Drawing Change Notice

CHANGE DOCUMENT NO.
24590-PTF-VDCN-MS-10-00007

JOB NO.	TITLE FOR CHANGE NOTICE
24590	UFP-VSL-00062A Redesign

JUSTIFICATION FOR CHANGE	CAUSE CODE
Based on the re-analysis of UFP-VSL-00062A, per calculation 24590-PTF-MVC-UFP-00023, for revised seismic conditions and design evolution, required a redesign of the vessel.	01 and 23

SECTION C-C
SCALE: 1/16

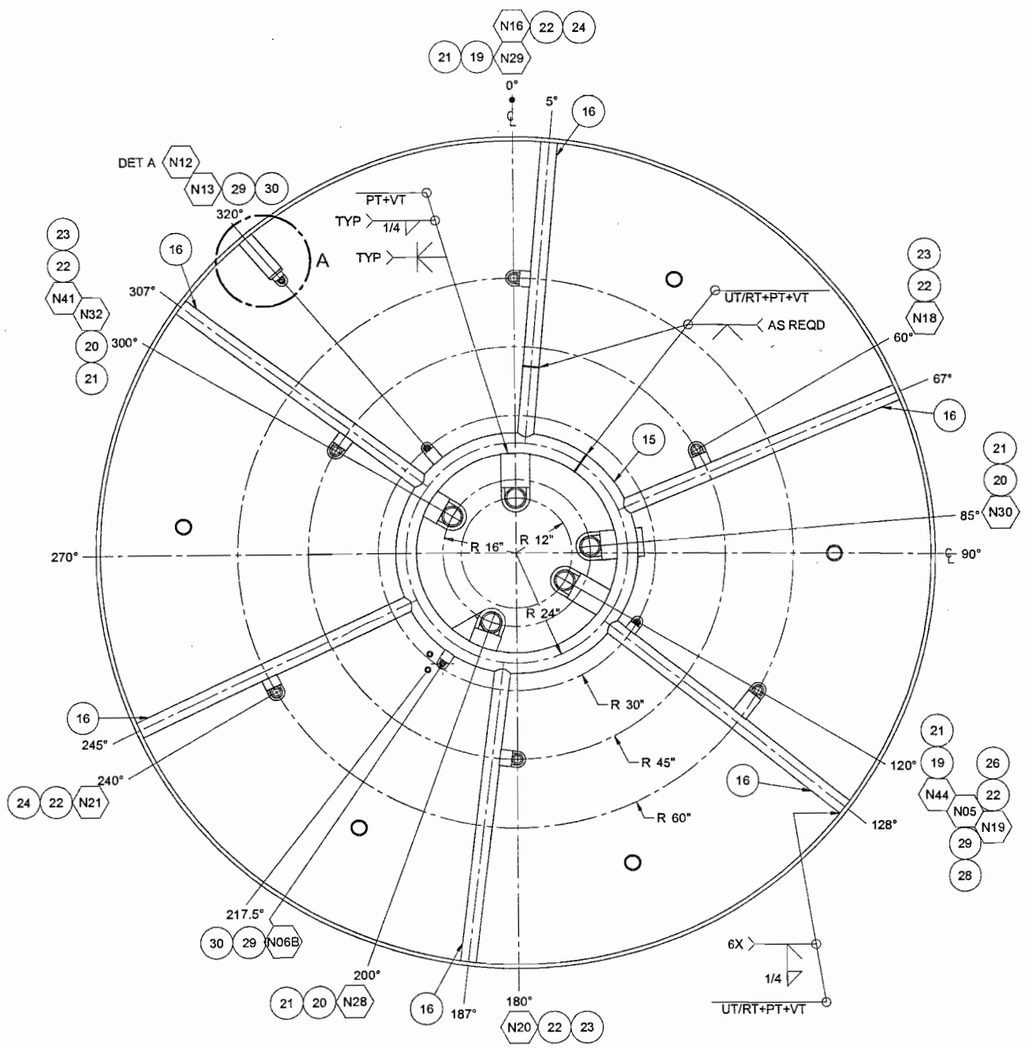
(1.) SECTION C-C

1. GUIDE RINGS ARE WELDED AFTER CORRECTLY POSITIONING THE GUIDE RING SUPPORTS. GUIDE RINGS SHALL MAINTAIN .125 DIAMETRAL CLEARANCE WITH PIPE.

DETAIL-A
SCALE: 1/4

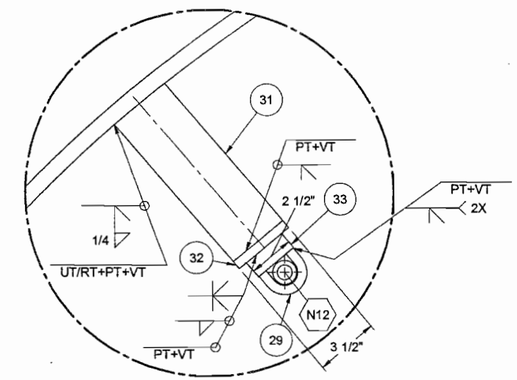
(2.) DETAIL-A

SECTION D-D
SCALE: 1/16

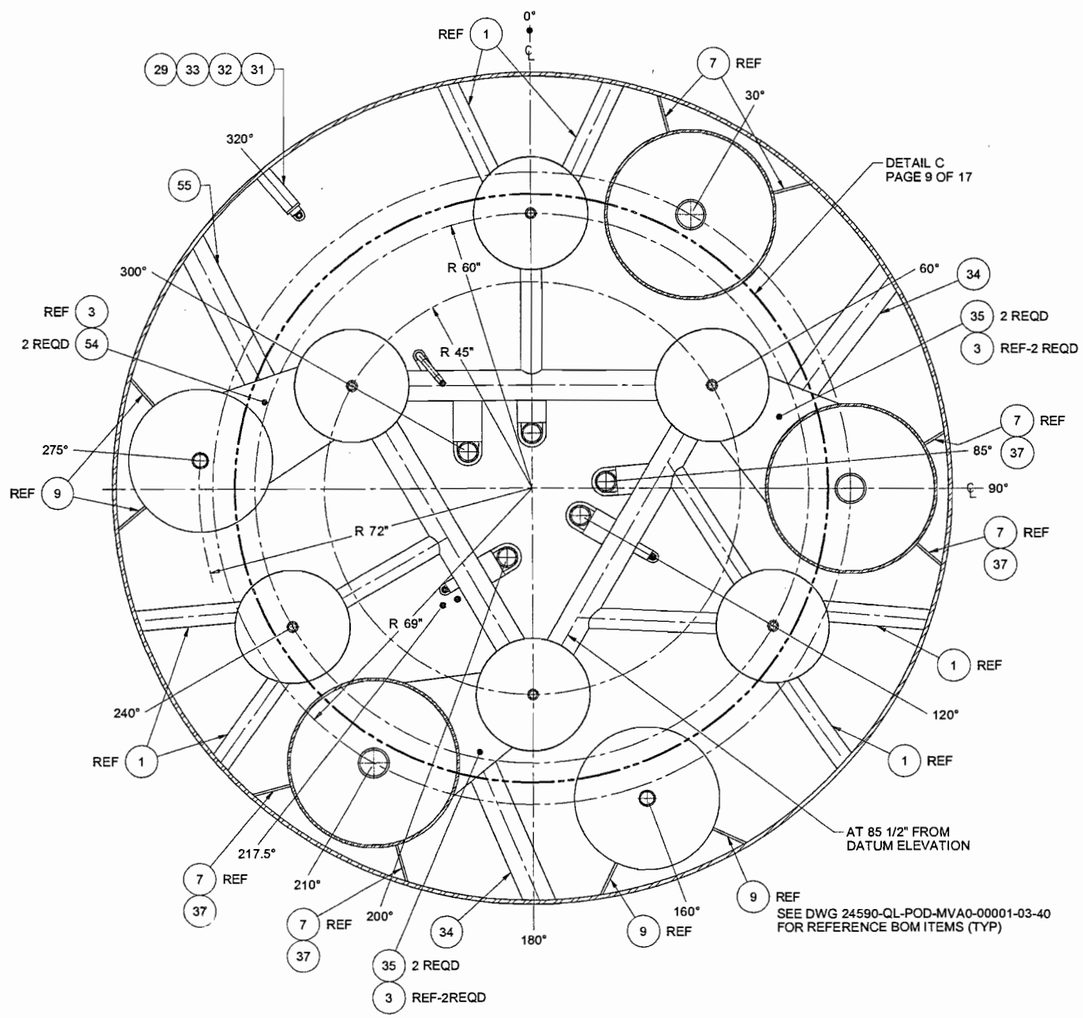
j.) Add SECTION D-D shown on Attachment 1, page 8 of this VDCN.

SECTION E-E
SCALE: 1/16

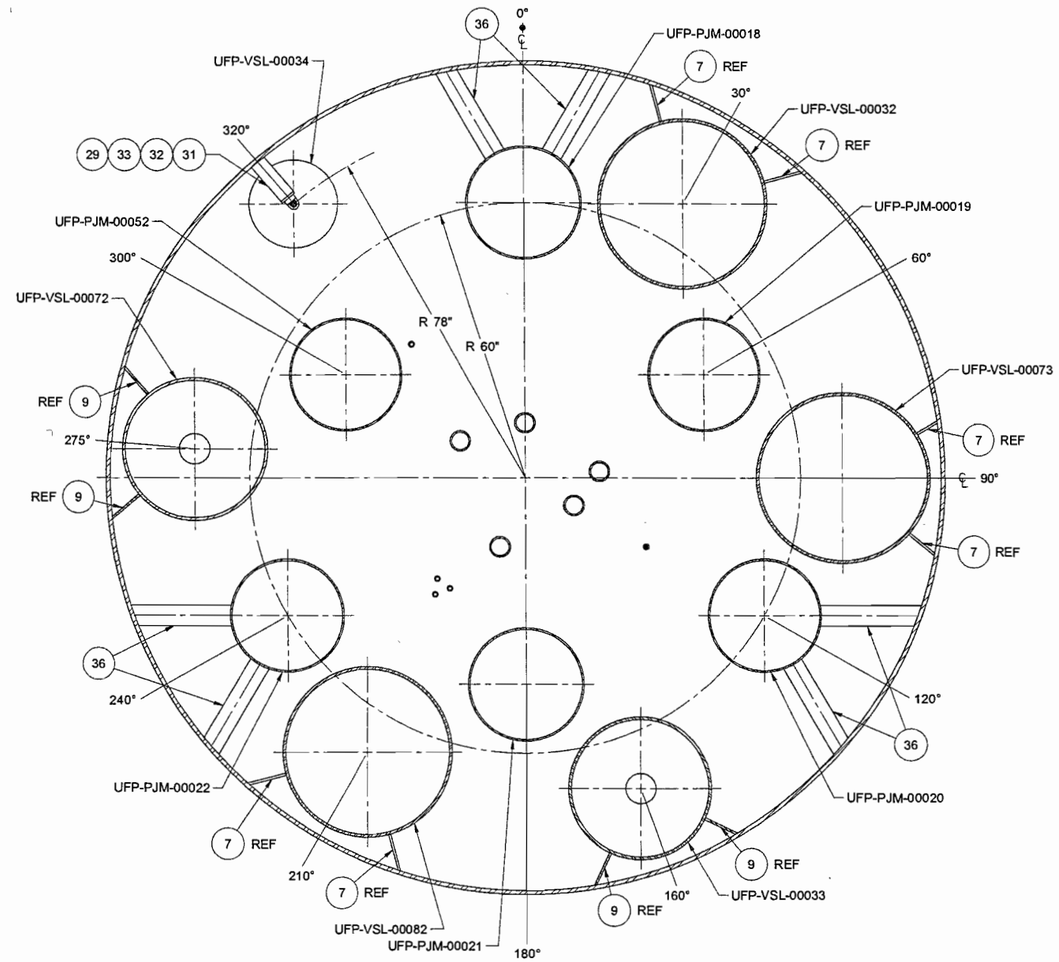
k.) Add SECTION E-E shown on Attachment 1, page 8 of this VDCN.

DETAIL C
SCALE: 1/8

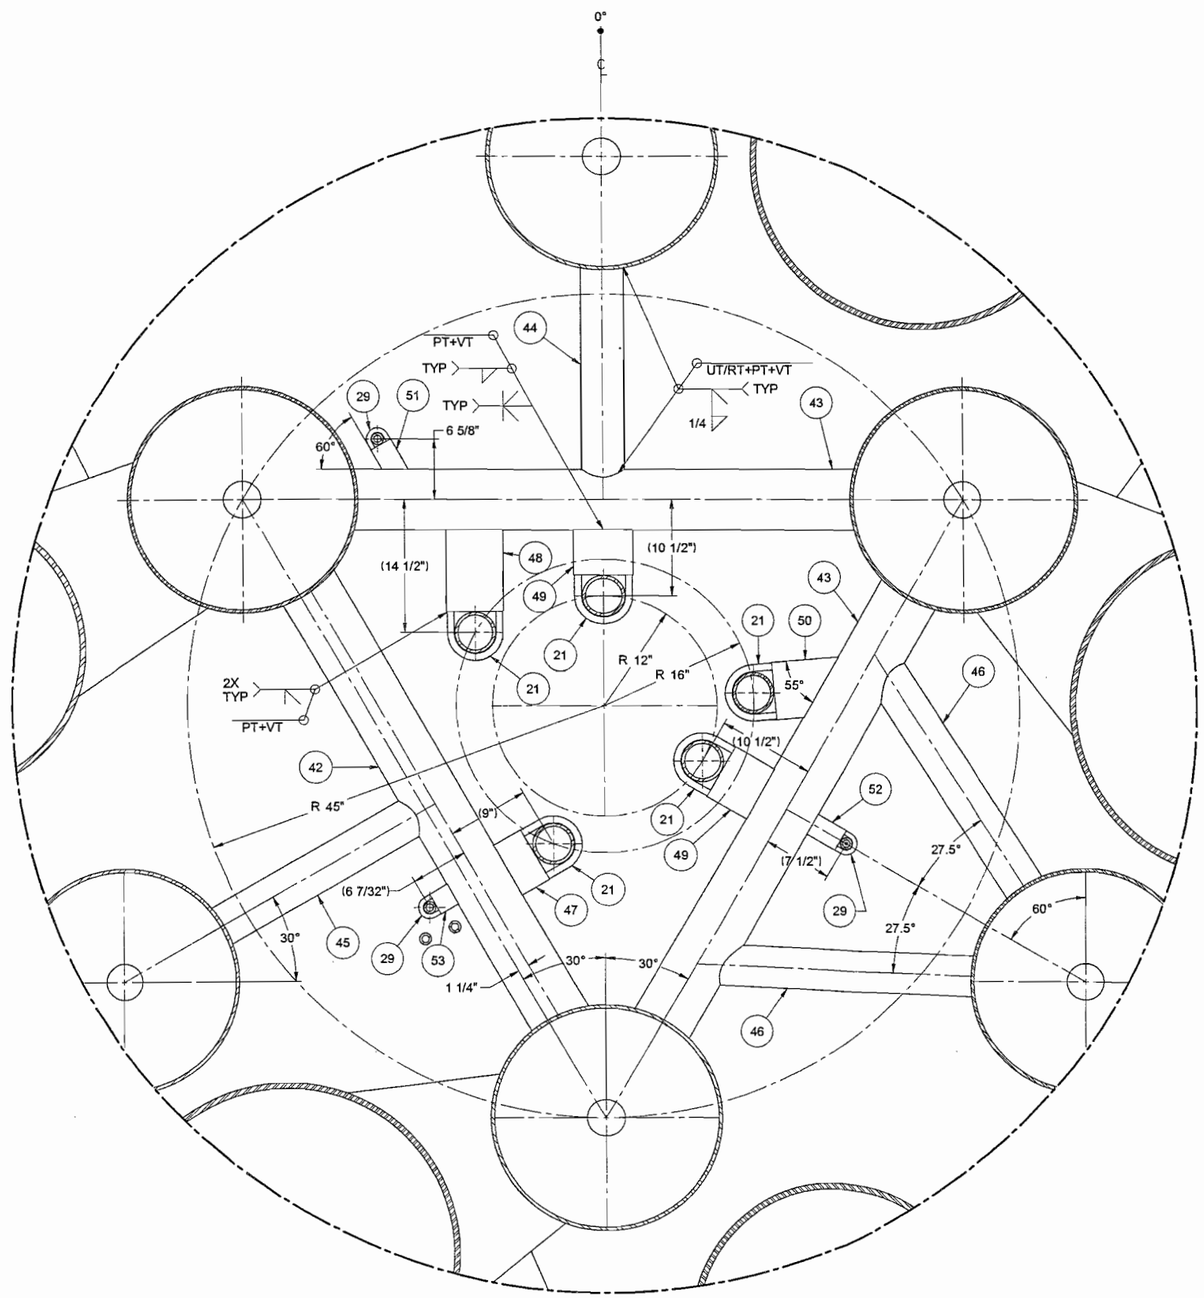
l.) Add Detail C shown on Attachment 1, page 9 of this VDCN.

2" SCH 80 NOZZLE W/ INT. PROJECTION
SCALE: 3/4" = 1"
NOT ~~N09~~ N10 N11 N14 2 3

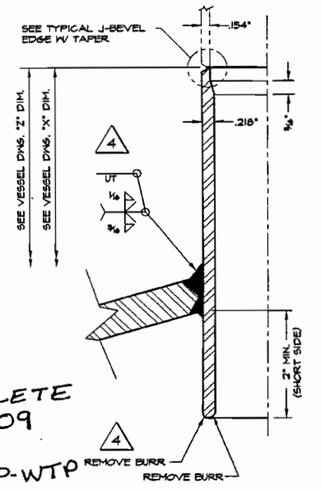
a.) 2" SCH 80 Nozzle W/ int. Projection: Delete N09.

DELETE N09 BY RPP-WTP

NOZZLE STUB SPLICE
SCALE: 3/4" = 1"
N44 4

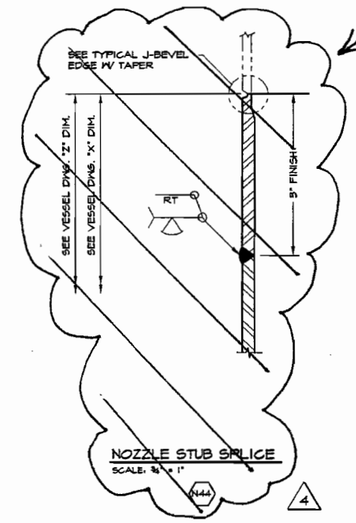
b.) Nozzle Stub Splice: Delete and replace with 'Typical SCH 160 Nozzle Detail.

DELETE AND REPLACE WITH TYPICAL SCH 160 NOZZLE DETAIL

2 TYP. LOWER SUPPORT FOR DIP TUBES
NO SCALE

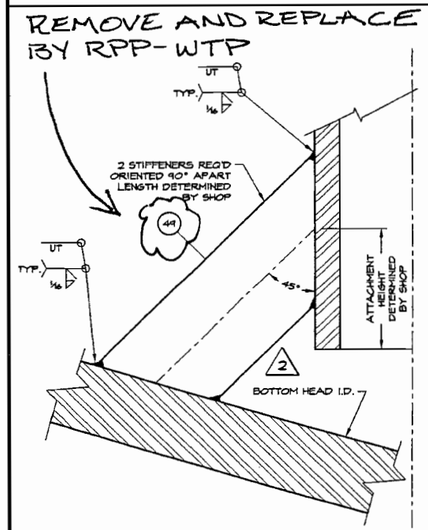
c.) Typ Lower Support For Dip Tubes: Remove support item 49.

REMOVE AND REPLACE BY RPP-WTP

NOTE: This support detail is covered on Vendor drawing 24590-QL-POD-MVA0-00001-03-22 as reflected in item 5 of this VDCN.

SECTION F-F
SCALE: 1/16

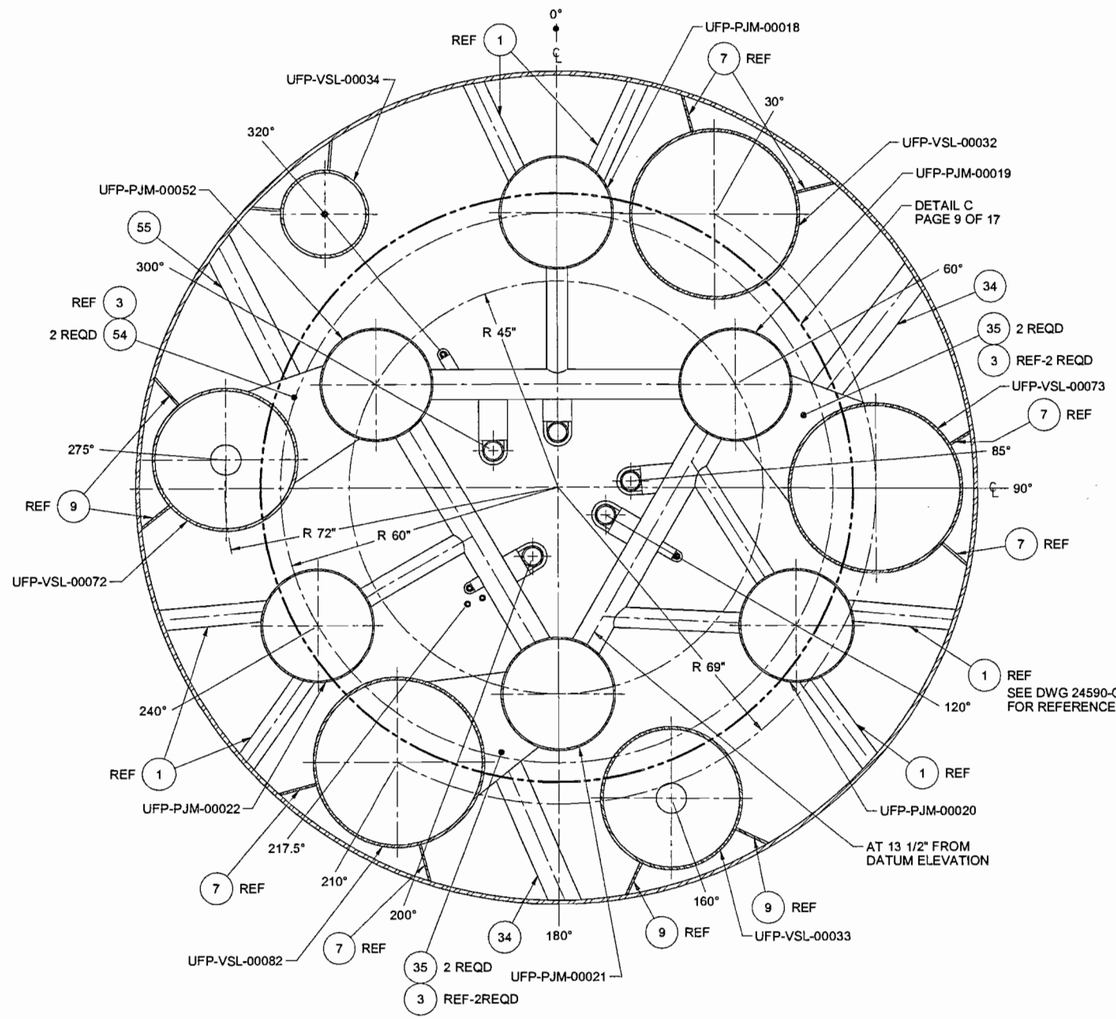
m.) Add SECTION F-F shown on Attachment 1, page 12 of this VDCN.

SECTION G-G
SCALE: 1/16

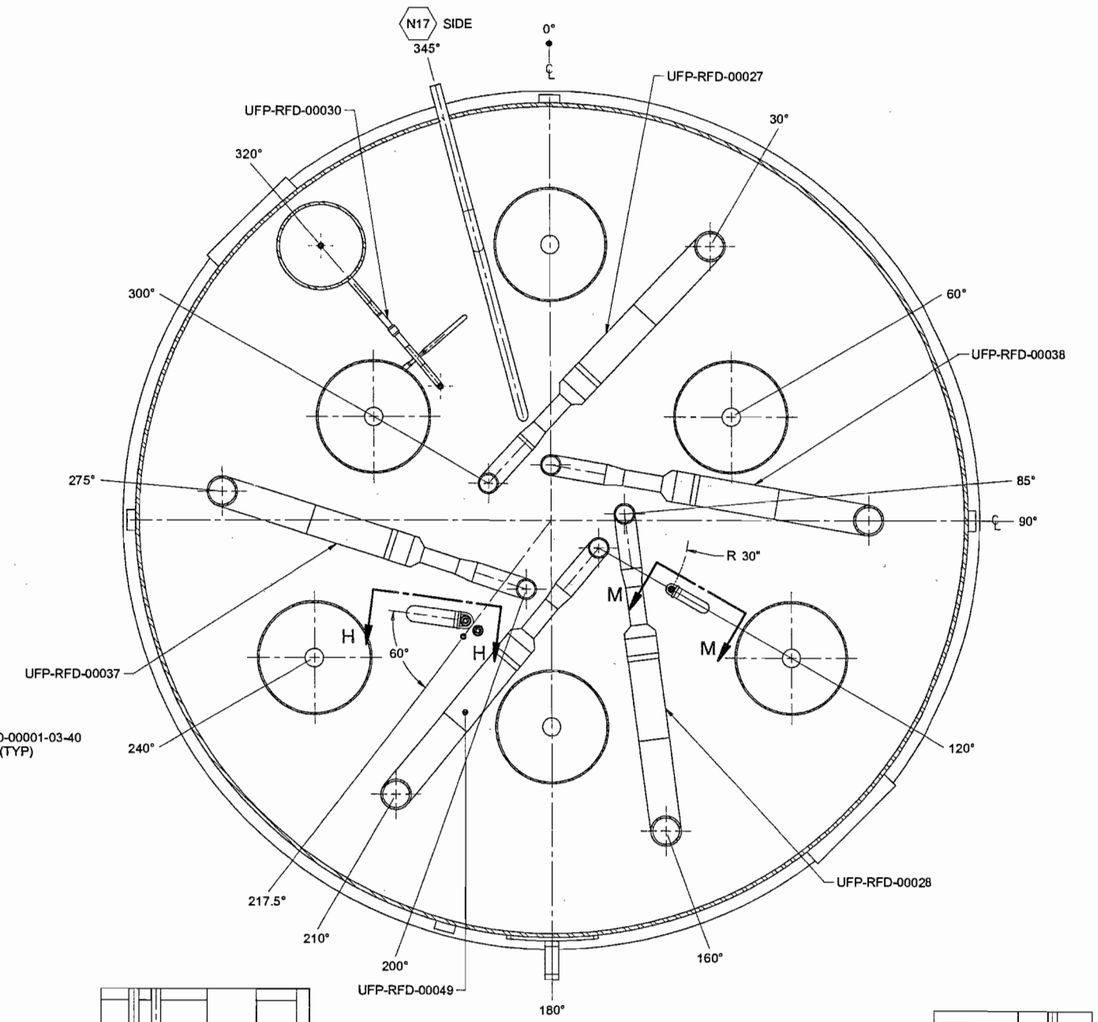
n.) Add SECTION G-G shown on Attachment 1, page 12 of this VDCN.

SECTION H-H
SCALE: 1/10

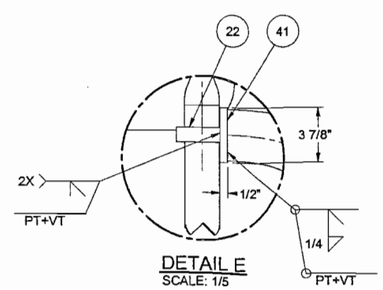
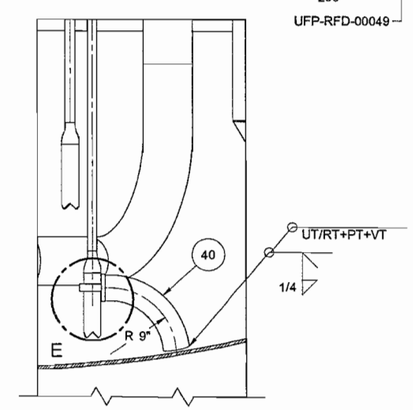
a.) Instrument Assy Detail: Remove support item 49 and replace with SECTION H-H and DETAIL-E shown on Attachment 1, page 12 of this VDCN.

SECTION M-M
SCALE: 1/10

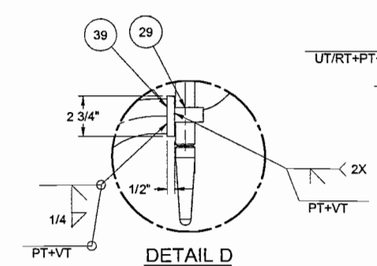
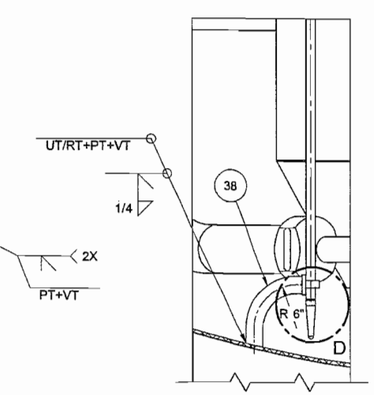
b.) Thermowell Assembly: Remove support item 49 and replace with SECTION M-M and DETAIL-D shown on Attachment 1, page 12 of this VDCN.

TYPICAL OUTER PJM PIPE SUPPORT
SCALE: ½" = 1'-0"

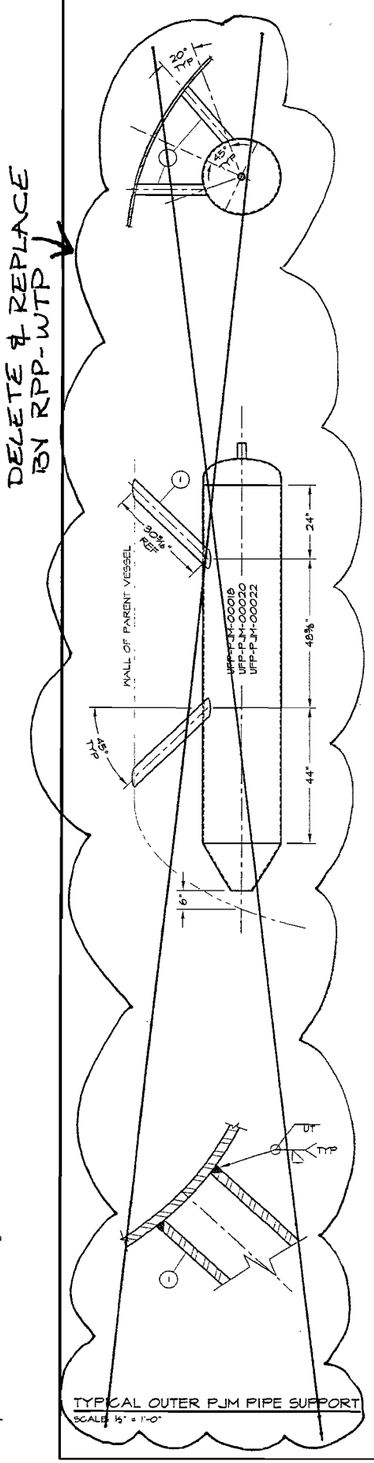
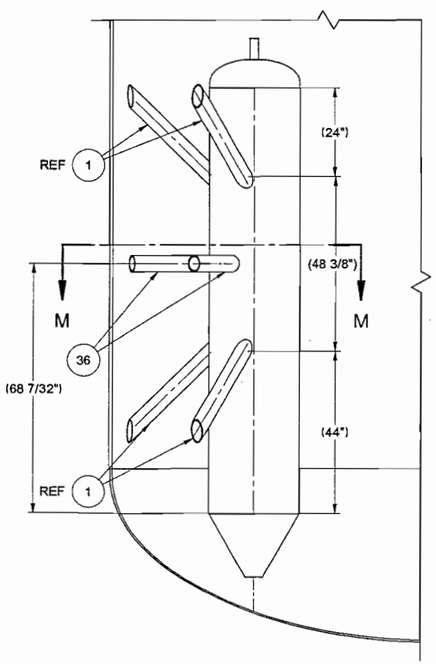
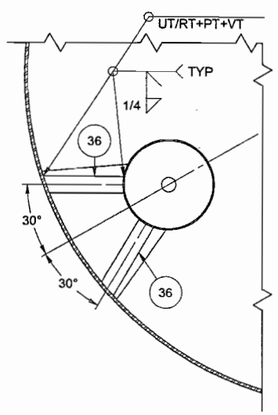
a.) Typical Outer PJM Pipe Support: Delete Typical Outer PJM Pipe Support view and replace with TYPICAL OUTER PJM SUPPORT, SECTION M-M and associated views shown on Attachment 1, page 16 of this VDCN.

DELETE & REPLACE BY RPP-WTP

30" CHARGE VESSEL & INNER PJM
SCALE: ½" = 1'-0"

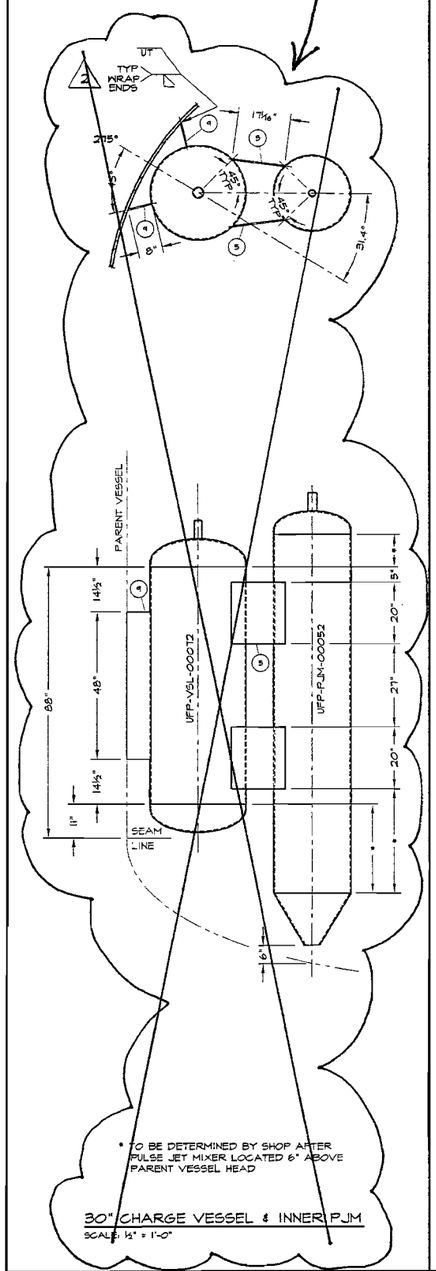
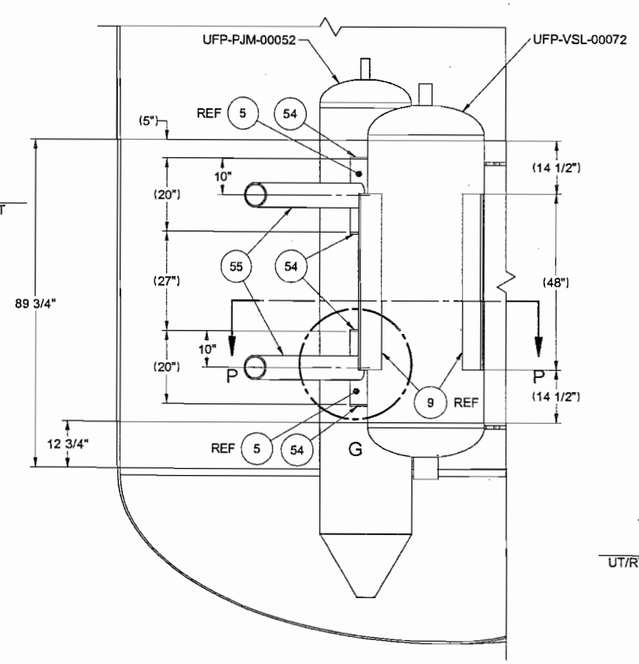
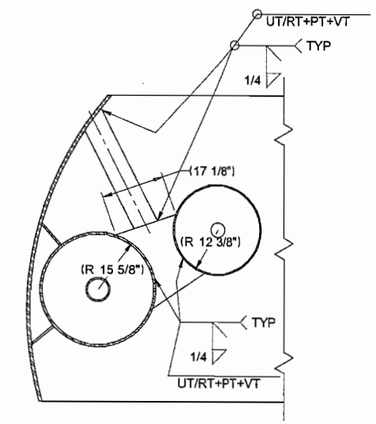
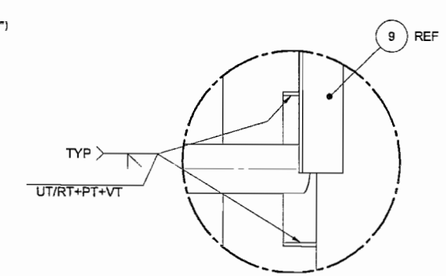
b.) 30" Charge Vessel & Inner PJM: Delete 30" Charge Vessel & Inner PJM view and replace with VIEW A, 30" CHARGE VESSEL & INNER PJM SUPPORT, SECTION P-P, item 54 DETAIL G and associated views shown on Attachment 1, page 14 of this VDCN.

DELETE & REPLACE BY RPP-WTP
